ARKANSAS
Department of Environmental Quality

RE: AFIN: 04-00175

Permit No.: 4438-WR-4

RE: Allens, Inc. – Plant #1
Information Related to August 28, 2012 Complaint

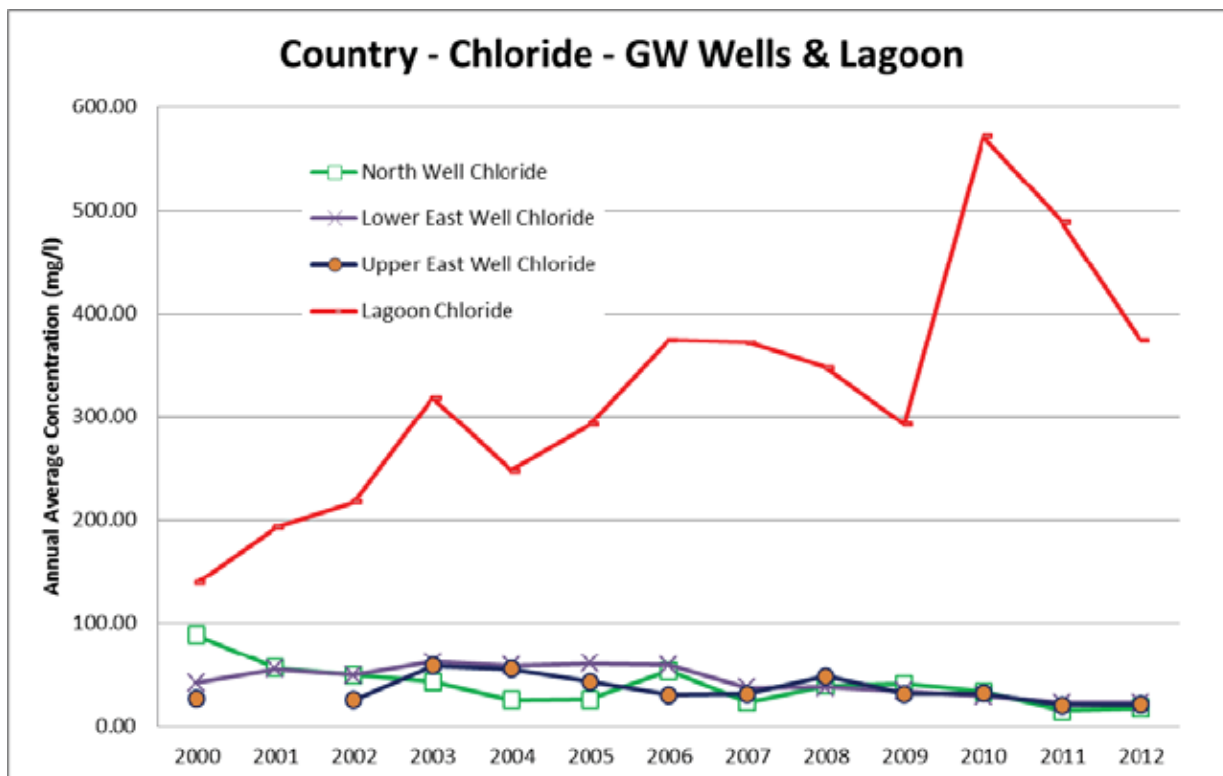
In response to the complaint, Allens contacted USI for input about the nature of construction of the pressure relief valves. USI has reiterated the need for hydrostatic relief, but did not provide a great deal of detail on their design, construction, or how they were attached. In fact, the valves do not appear on USI’s drawings (copy attached). As best as USI can recollect, they believe the pressure relief valves were installed by the lining contractor.

“Sathi, here is a detail of the air relief flap for the liner. It was to release any gas or air that may get between the HDPE liner and the concrete liner. There were no pressure relief valves installed with the liner. The things that became detached are de-watering ports utilized by the liner installing contractor to facilitate installation of the liner. These were necessary to lower the surrounding ground water table to prevent it from pushing the concrete out and into the lagoon. The existing plans of record did indicate that there were pressure relief valves installed. But, I don’t think they were. That’s why the liner contractor installed the PVC pipes for dewatering. This is stated in my letter to Laura, dated December 17, 2007. The Type of PRV that was specified was constructed of cast iron. Our experience has been that these do not perform well

due to corrosion. PRV's are necessary, though, to prevent the heaving of the liners due to hydrostatic pressure caused by the surrounding ground water. The flap is found on page 25 of the attachment".

Based on the above correspondence with USI, there is a clear misunderstanding of relief valve and relief flap among the wastewater employees. So, what surfaced in the wastewater lagoon is 2-inch white PVC pipe with a cap that was installed by the liner contractor for groundwater dewatering purposes during the liner installation. Also, USI informed us verbally that the PVC pipe is grouted in the bottom.
